**Re: Proposed Conventional/Bare Land Strata Subdivision Application for
PID 015-931-901, Block A (Reference Plan 1657), District Lot 1427, Group 1,
NWD, Except Portions in Plans 7134, 7360, 7481 and 7697**

RE: Planning Project Application Requirements Letter – Proposed 29-Lot Subdivision at Priestland Road, PID 015-931-901 (Application # SD000022, 2017-04710)

Staff have completed the formal review of a second submission containing a revised plan for subdivision application SD000022, and comments are summarized in and/or attached to this letter. Comments are based on Ministry of Transportation and Infrastructure (MoTI) referral 2017-04710 from the applicant's revised subdivision proposal, received by SCR D June 28, 2023. The referral package included the following:

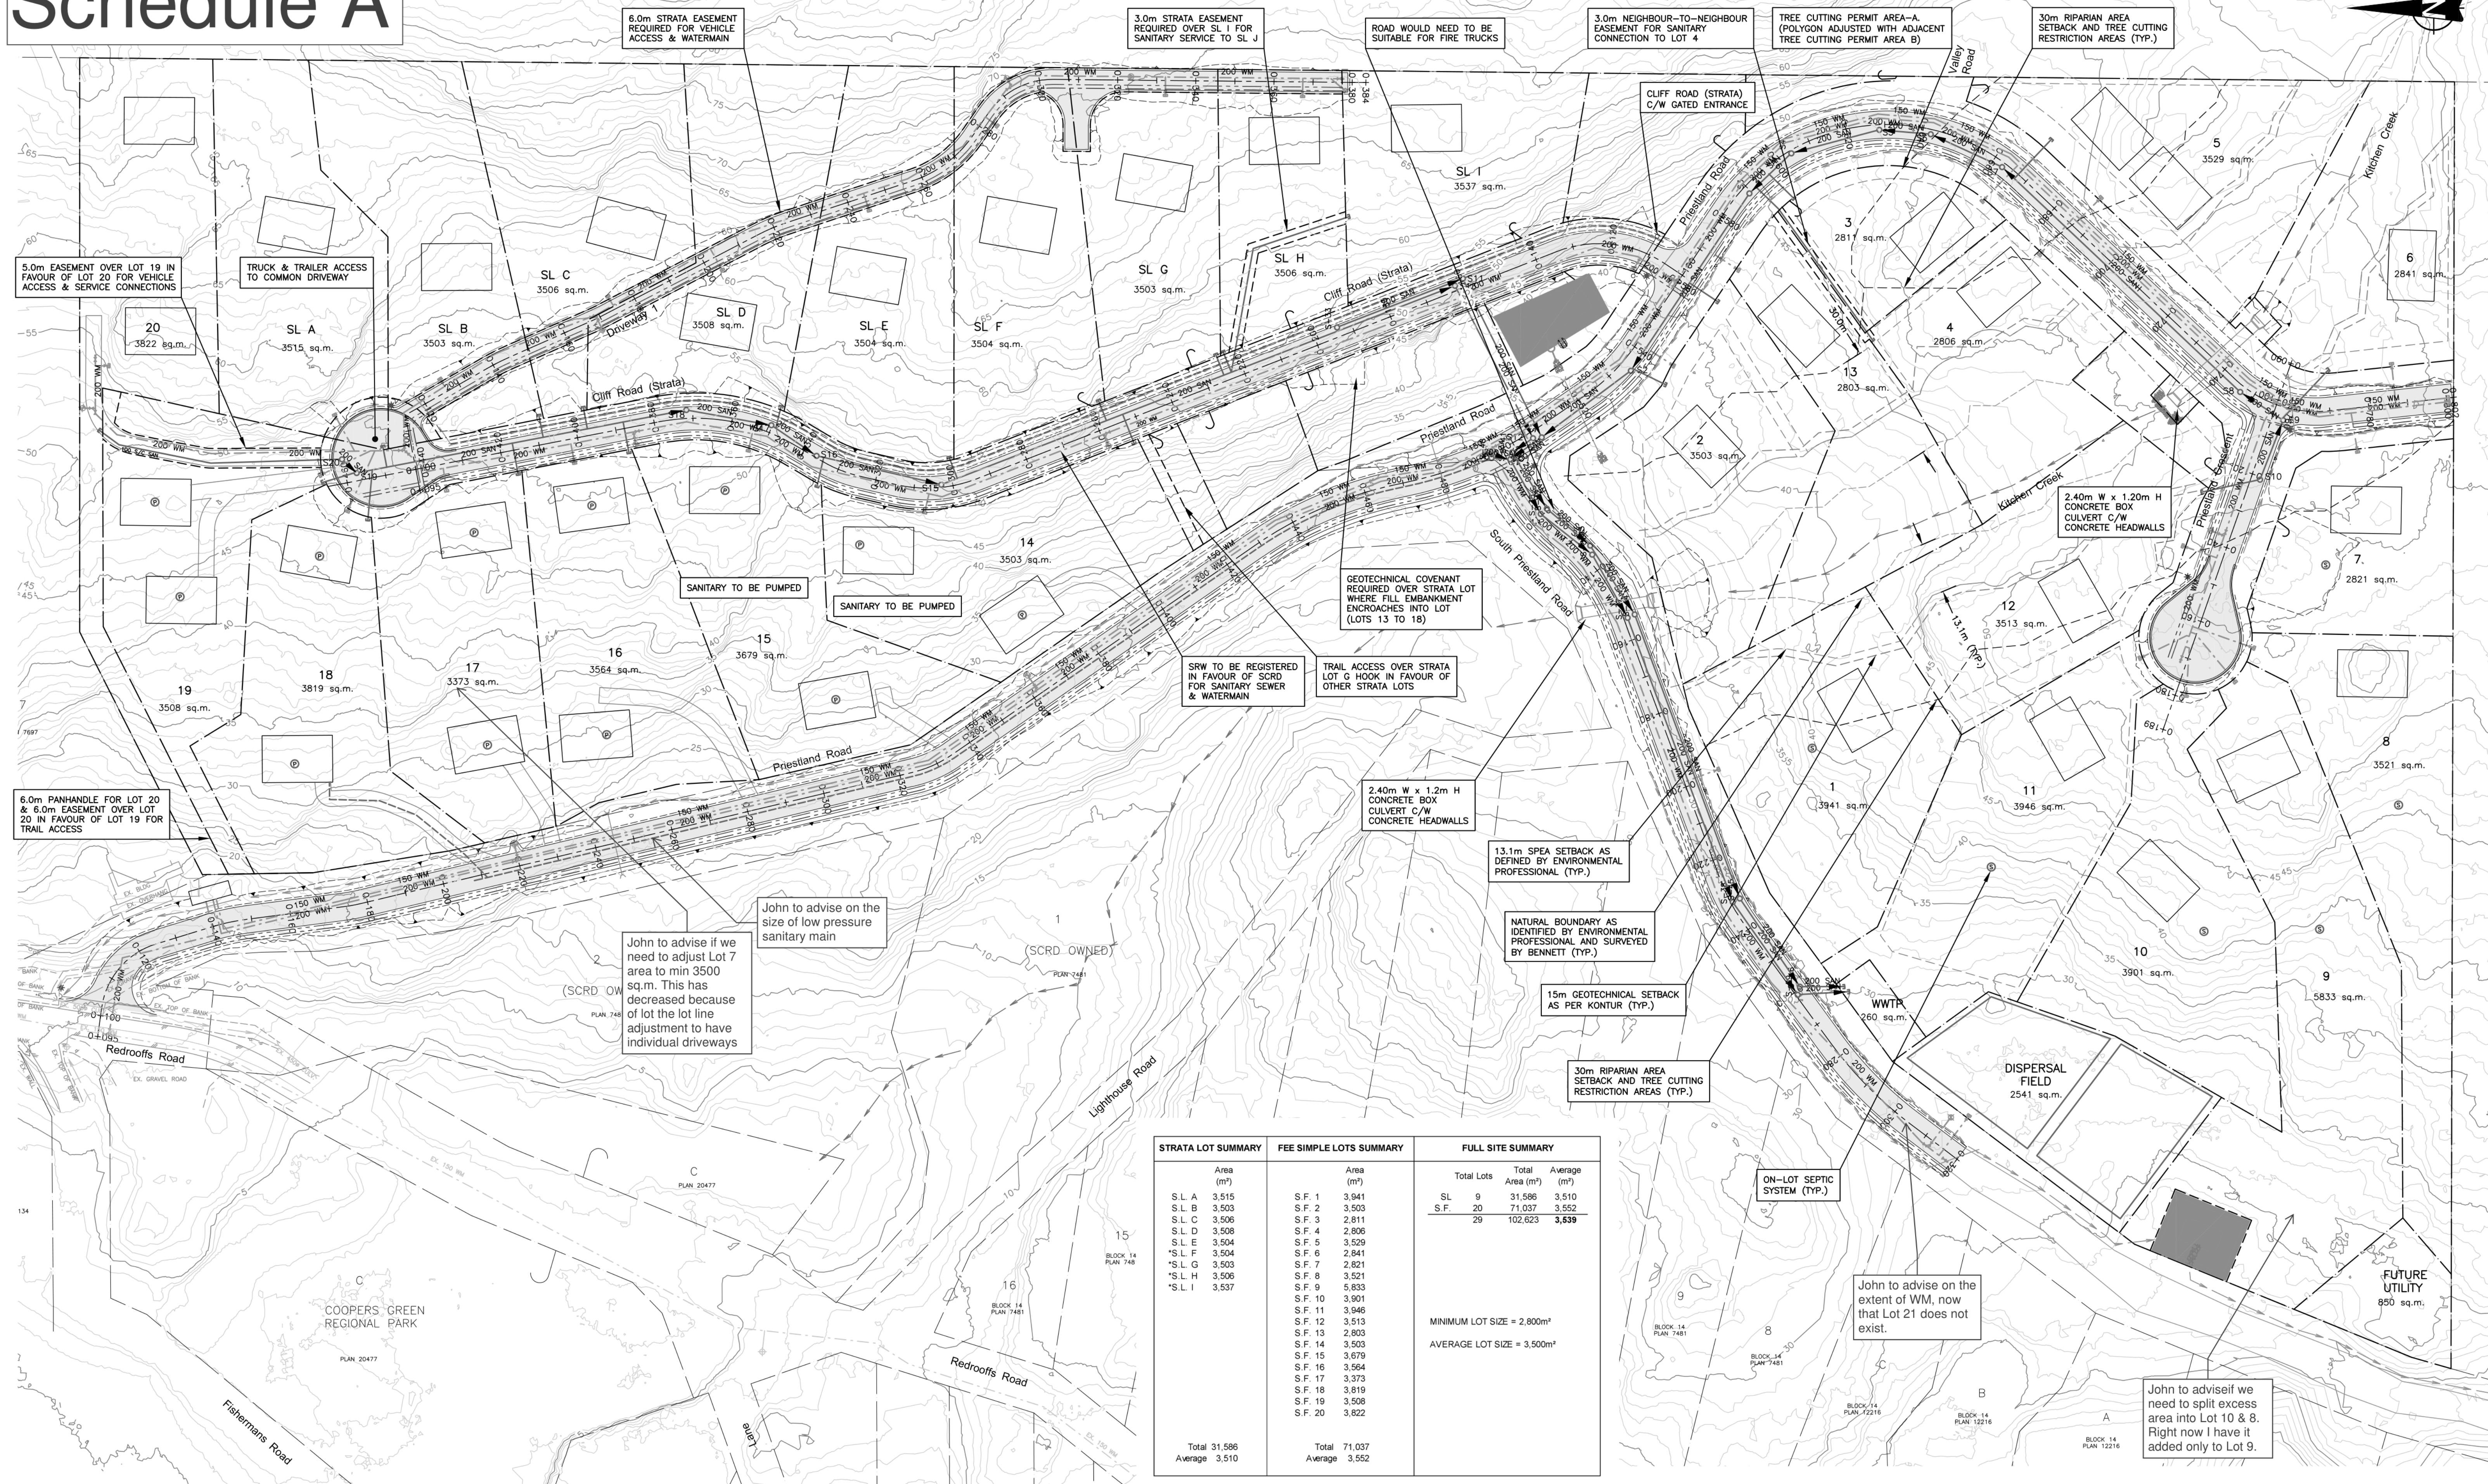
Additional to this, I question why lots with strata road access are accessing to the public road (two via panhandles from a very long distance – why!). There are no Strata Road design drawings included in this package – I understand this is under purview of the PAO. **Jeff** – if you'd like my feedback on the Strata Road design, let me know and I'll be happy to review geometrics on that!

- We need a separate DCS for each road being constructed.
- DCS is required to use MOTI Functional and Design Classifications.
- Subdivision roads are not Low Volume Roads. Please revise classification.

- Dimensions for cul-de-sac aren't given. Cul-de-sac must be designed per figure 1420.G of the BC Supplement
- Given horizontal and vertical curves through intersections, sight triangles and sight distances need to be confirmed.

Subdivision Plans (Webster Engineering) dated April 7, 2021

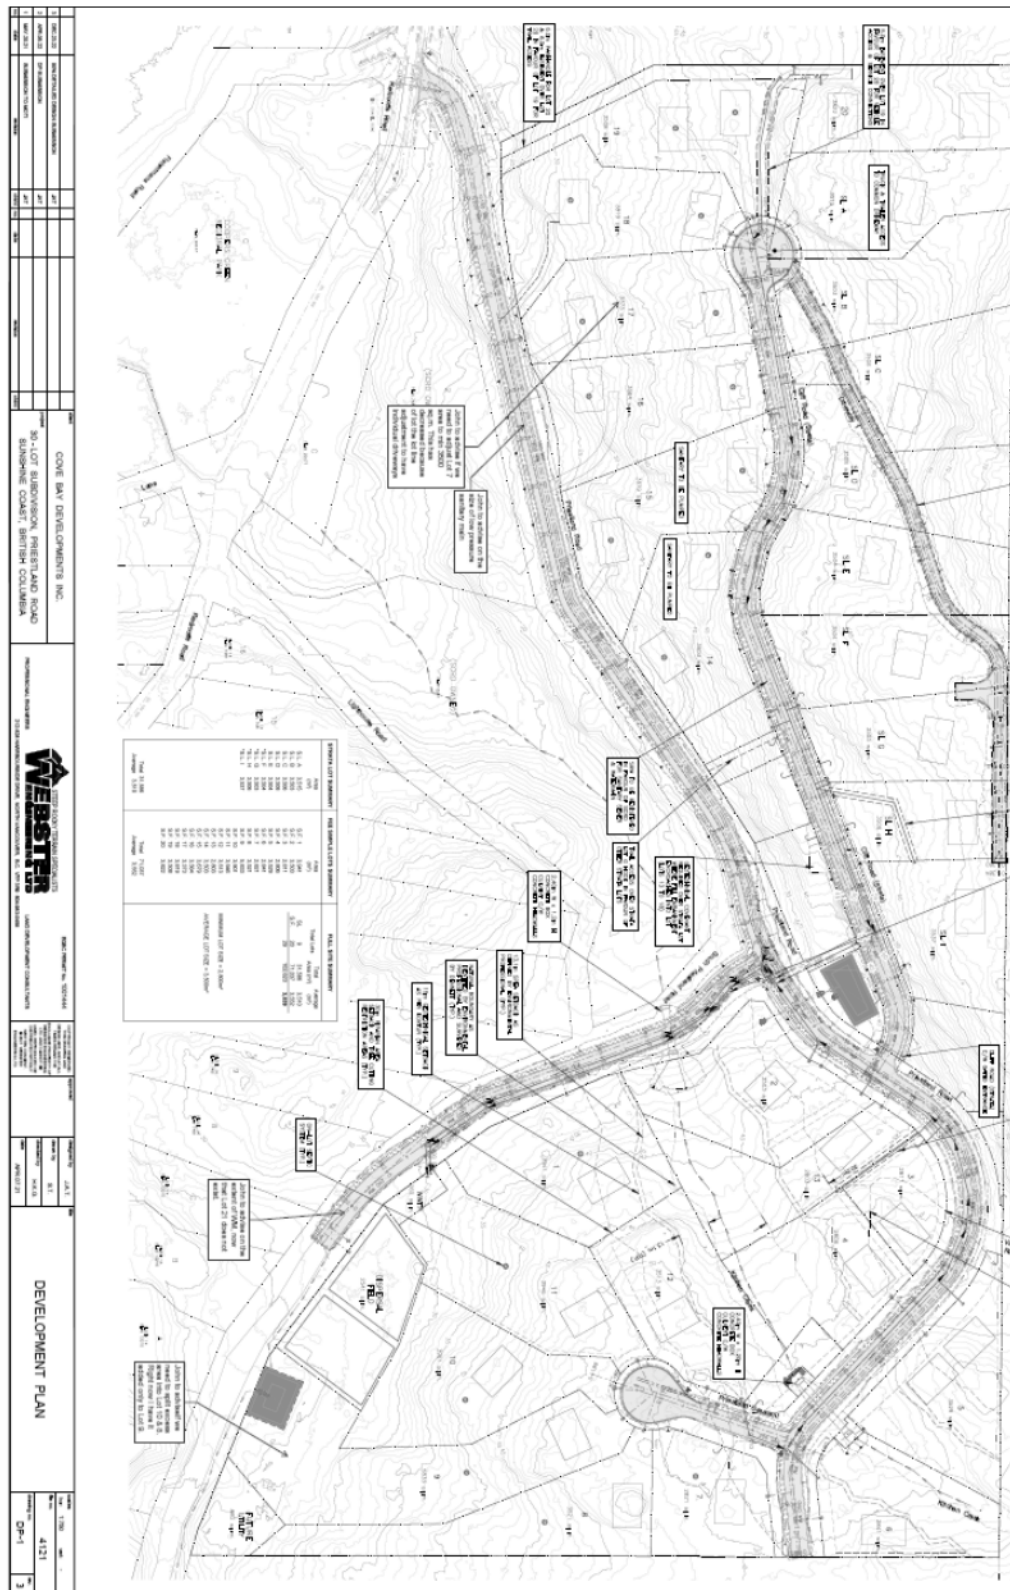
The proposed Subdivision Plan contains hooked parcels that are not in compliance with Section 4.4.1, as noted above, and the applicant is required to provide the following:

Based on the proposed Subdivision Plans, staff have identified several parcels that appear to require consideration of an exemption through a Frontage Waiver Application.

- i. A Frontage Waiver Application is required. This application would be presented to SCRD Board for consideration. If an application is made, the applicant is to provide a written rationale for each requested waiver to the minimum statutory frontage, along with a plan clearly identifying parcels subject to proposed frontage waivers and the proposed frontage, expressed in both metres and as a percent of the total parcel perimeter. Staff note the written rationales should speak to how each requested frontage waiver will comprehensively enhance the proposed subdivision layout (i.e. promote riparian enhancements, transportation safety).
